KEADBY 3 CARBON CAPTURE POWER STATION

Document Ref: 10.6

**Proposed Development Changes:
Environmental Statement (ES) Addendum
Non-Technical Summary**

Date: April 2022

Figure NTS4: Order Limit Changes

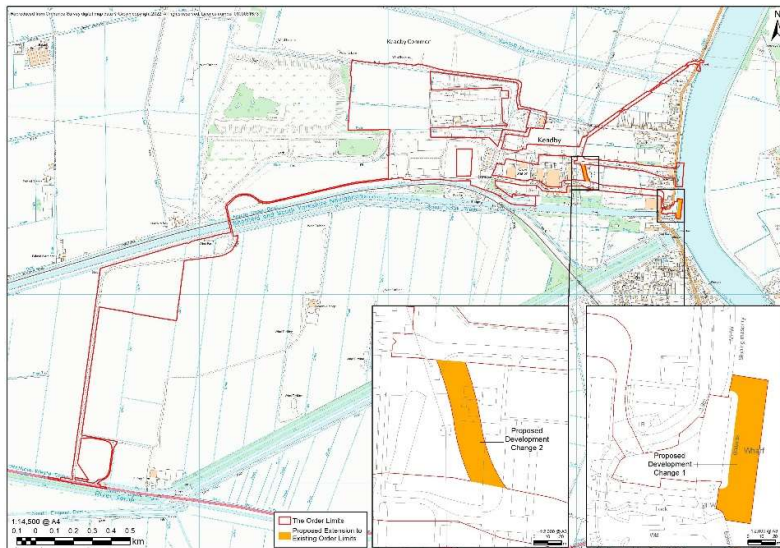
3.2.5 The two Proposed Development Changes that affect the Order Limits are as follows:

- Proposed Development Change 1: addition of a section of river bed to be used by moored vessels in the Waterborne Transport Off-loading Area.
- Proposed Development Change 2: Extension to the All Route through Keadby 1 Power Station outage/contractor compound, which runs through semi-improved grassland/scrub and hardstanding land occupied by services.

Figure NTS7: Indicative Proposed PCC Site Layout Twin Absorber

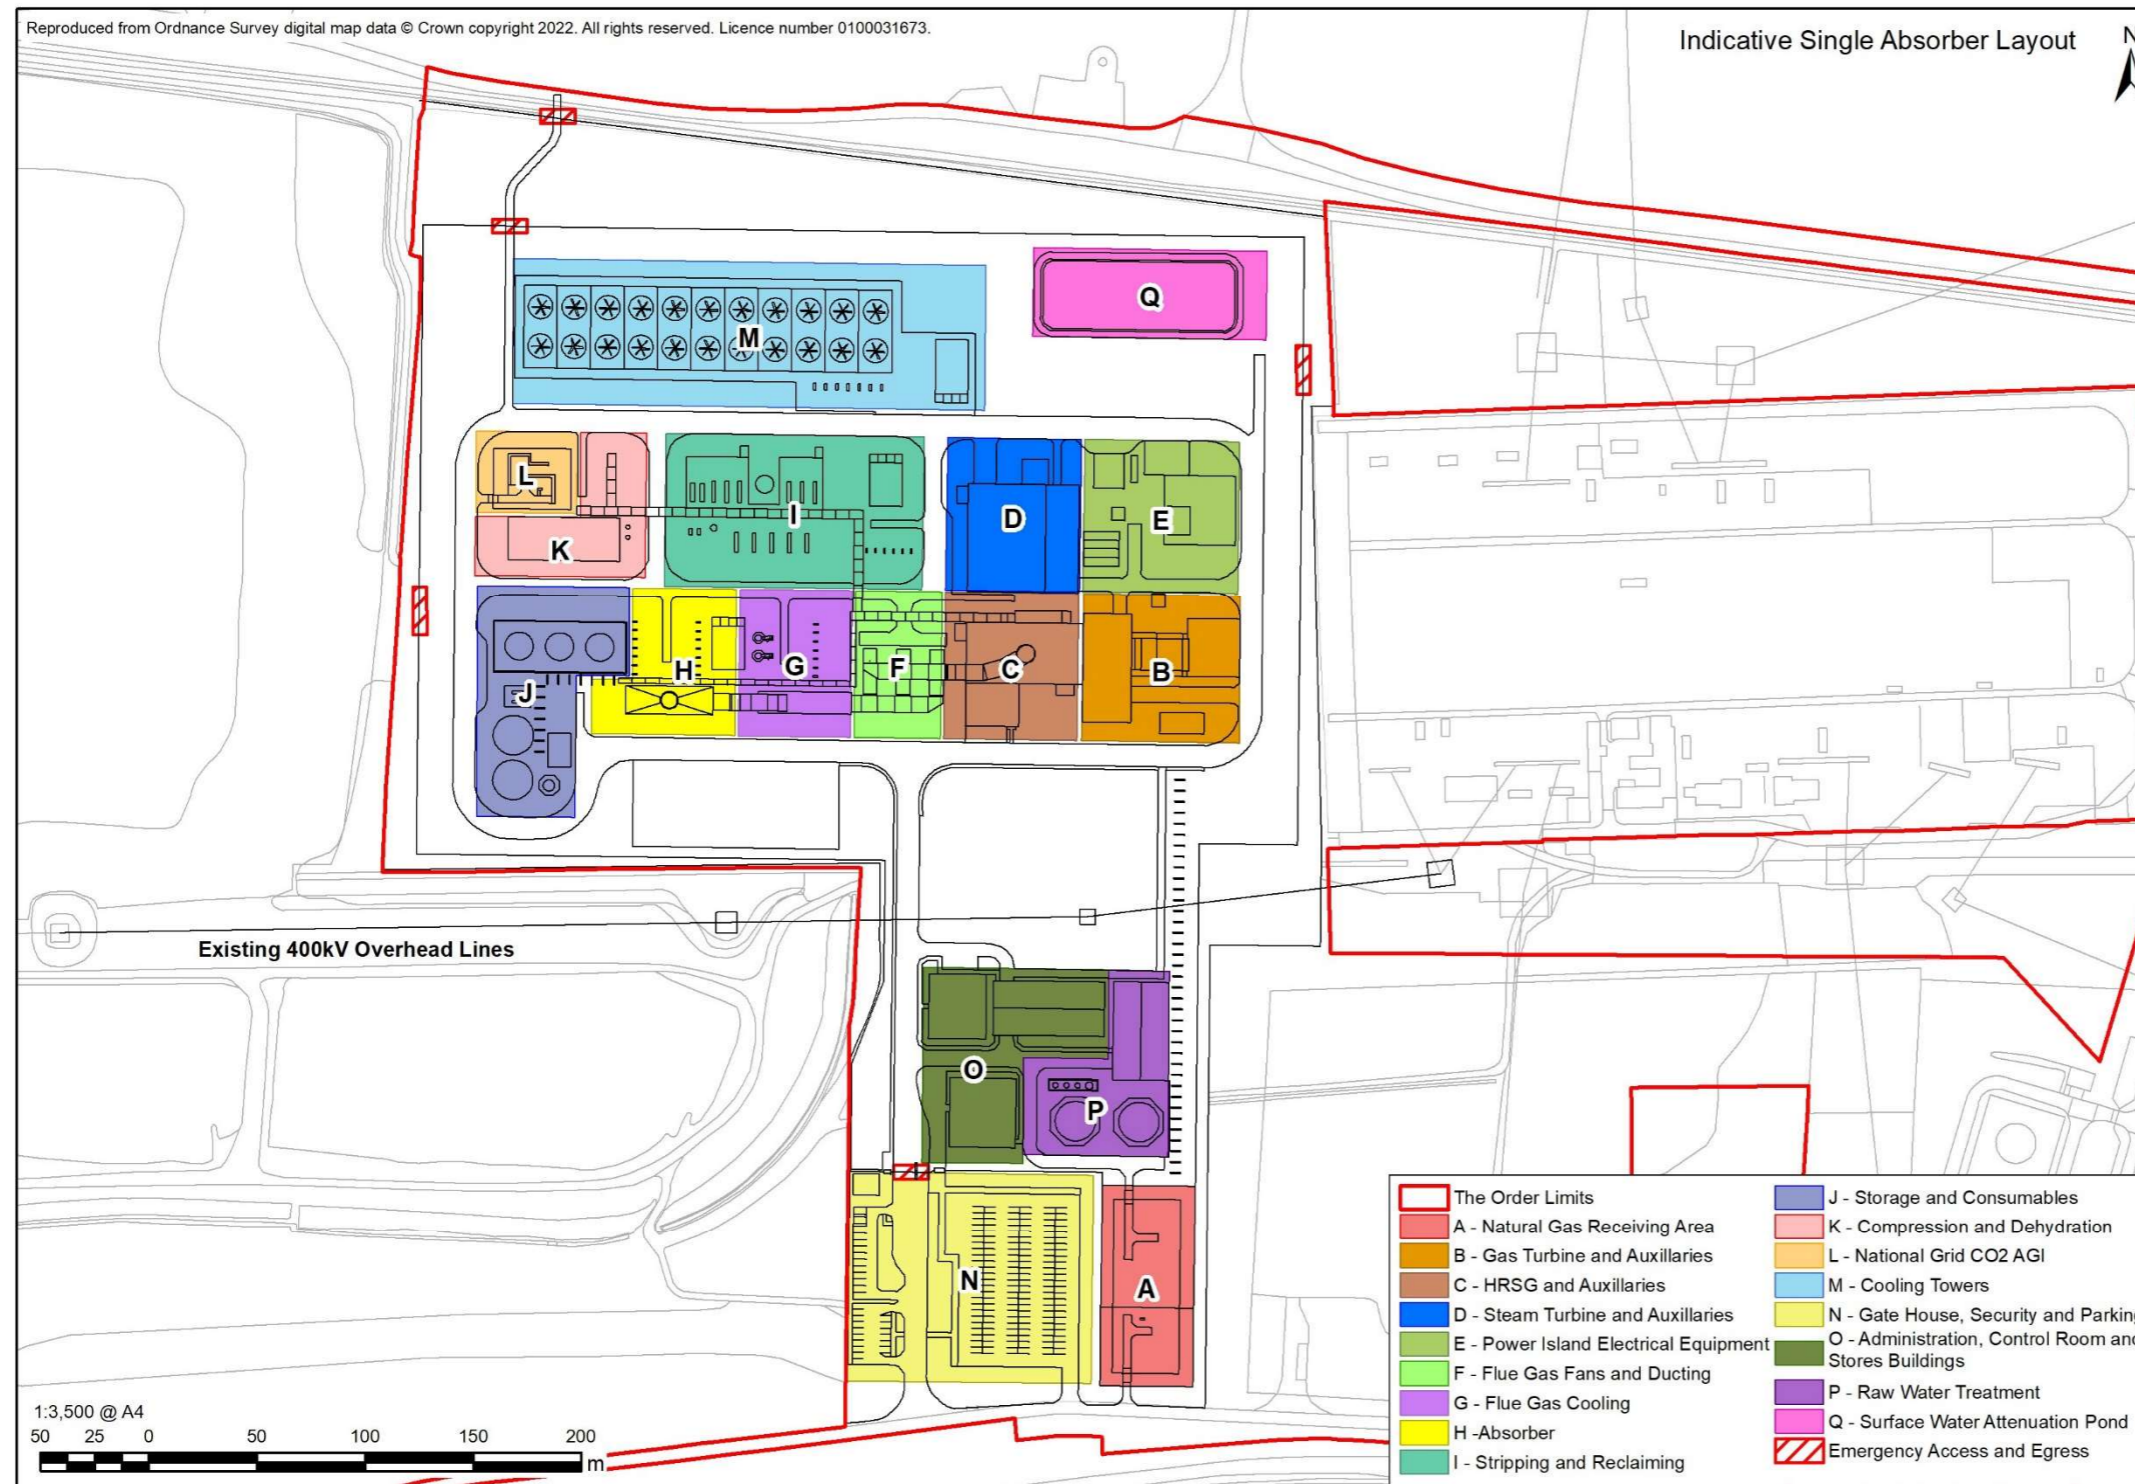
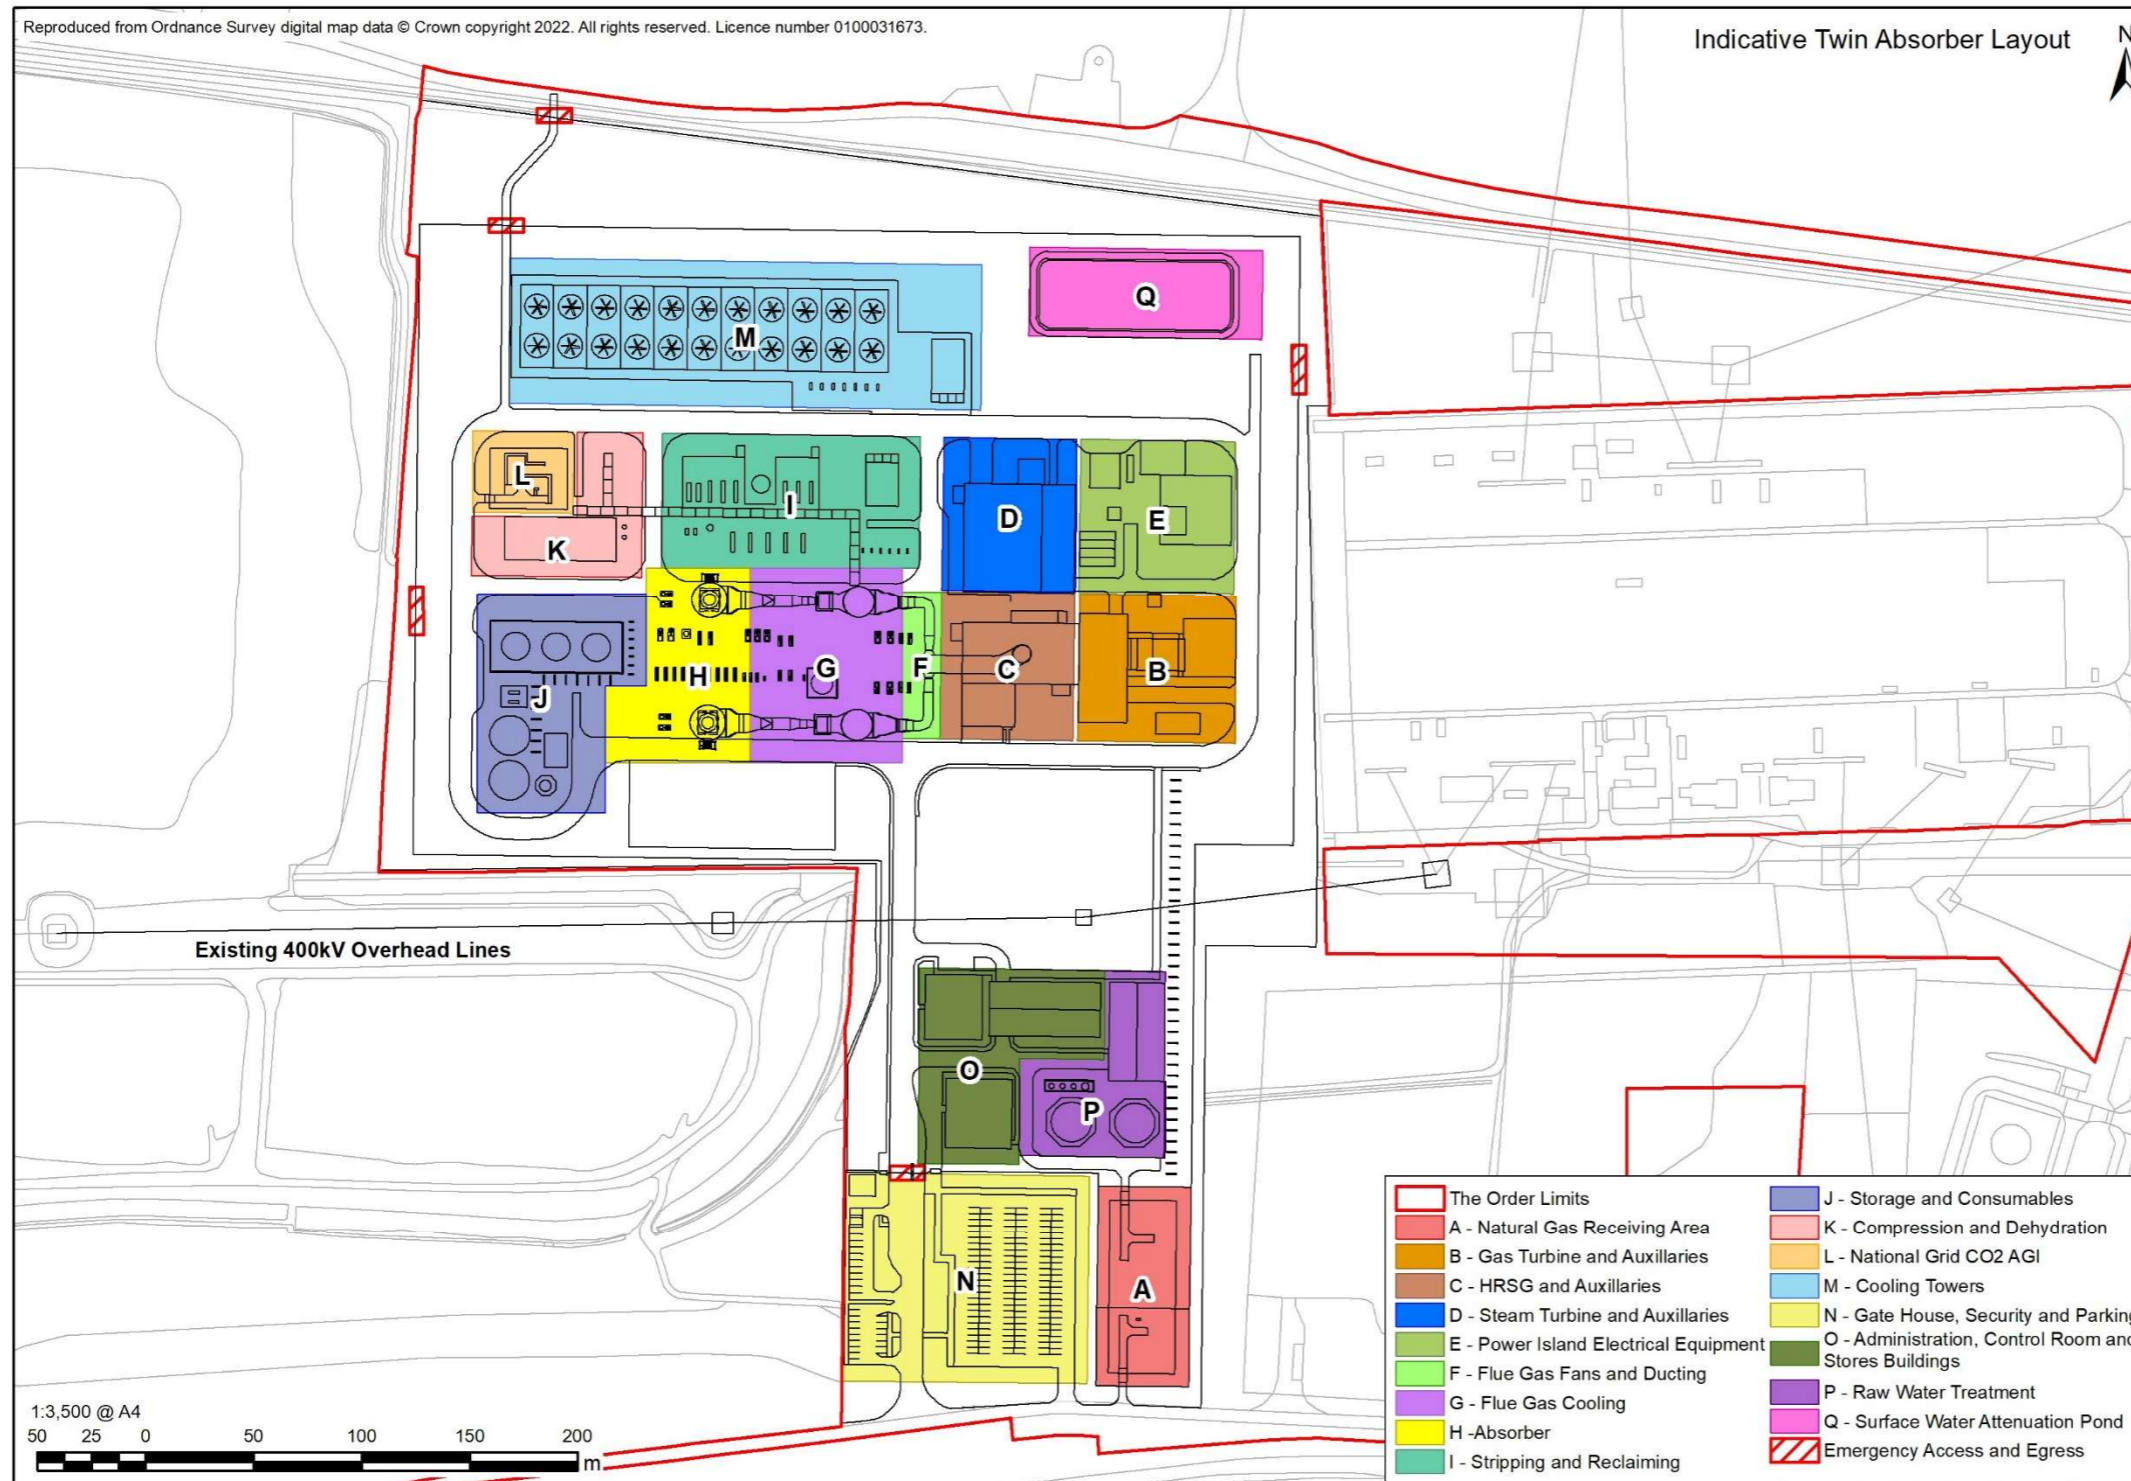
- **Change 3: Increase to the maximum parameters (height) for up to two absorbers/ stacks.** Ongoing engagement with design contractors has identified that in the event that two absorbers are required for the removal of CO₂ from flue gases within the CCP (Work No. 1C), the twin absorber units and stacks may extend to a maximum height of up to 80m above ground level (AGL) for the absorber towers and an additional up to 15.5m in height for the stacks i.e. up to 95.5m AGL in total, which equates to a maximum of 98.3m Above Ordnance Datum (AOD) for each absorber and associated stack. These maximum dimensions – established through ongoing design development - are approximately 20m higher than those previously assessed for the twin absorber option in the submitted ES and presented as a parameter in the draft DCO [APP-005], albeit they are still lower than the maximum height assessed for the single absorber option.

4.2.4 **Figures NTS6 and NTS7** show an indicative layout of the Proposed PCC Site. Figure NTS6 shows the indicative layout of the Proposed PCC Site with a single absorber installed. Figure NTS7 shows the indicative layout of the Proposed PCC Site based on the twin absorber option. The CCGT and CCP including absorber stack(s) would still be

Figure NTS8: Abnormal Indivisible Load Route from Wharf

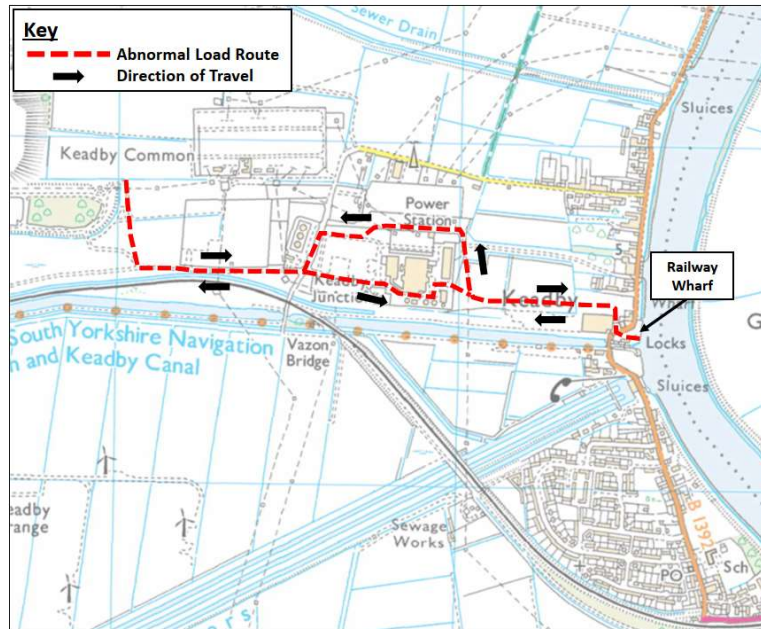
- **Change 2: Changes to the Additional AIL Route (Work No. 10A) (Contractor/ outage compound area, east of Keadby 1 Power Station and north of Keadby 1 Power Station); all within land under the control of the Applicant** The Applicant proposes an extension to the AIL Route (**Work No. 10A**), to avoid reliance on routing all AILs through Keadby Power Station due to this being an operational site with the potential for health and safety risks and for this to potentially affect the construction timescale of this nationally significant infrastructure. This extension utilises land within the Keadby power station site that is currently used as a contractor/ outage compound area, east and north of the Keadby 1 Power Station which is all within land under the control of the Applicant. Demolition/ relocation of several small existing Keadby 1 Power Station buildings/ offices within this area may be required. The route would seek to avoid loss of and disturbance to existing vegetation, although where permanent loss of vegetation is unavoidable, compensation/ enhancement of biodiversity including replacement tree planting would be undertaken. Figure NTS8 shows the route.

- Where the route of the Additional AIL Route crosses existing services including Keadby 1 cooling water pipework, a temporary piled steel bridge structure would be used to minimise risk of damage to the pipework and other services. Other parts of the AIL Route extension would be constructed using similar materials and techniques to the existing retained AIL Route created for Keadby 2 Power Station construction. Vehicles using the AIL Route extension to deliver AILs would travel west along the northern boundary of Keadby 1 Power Station, within the Order Limits, and then cross Chapel Lane making use of existing site roads adjacent to the existing above ground tank farm to re-join the existing AIL Route along Bonnyhale Road.

- **Proposed Development Change 2: Figure NTS8**
 - The temporary haul road will be constructed using geotextile separation membrane with granular compacted stone laid on top and using a temporary piled steel bridge to span the Keadby 1 cooling pipeline.
 - Temporary steel bridges will be used to span two drainage ditches and Keadby 1 cooling water pipework.
 - Following construction of the extension to the AIL Route, enhancement of habitats within the route will be undertaken as part of the overall landscape and biodiversity management and enhancement proposals (**Work No. 11a**).
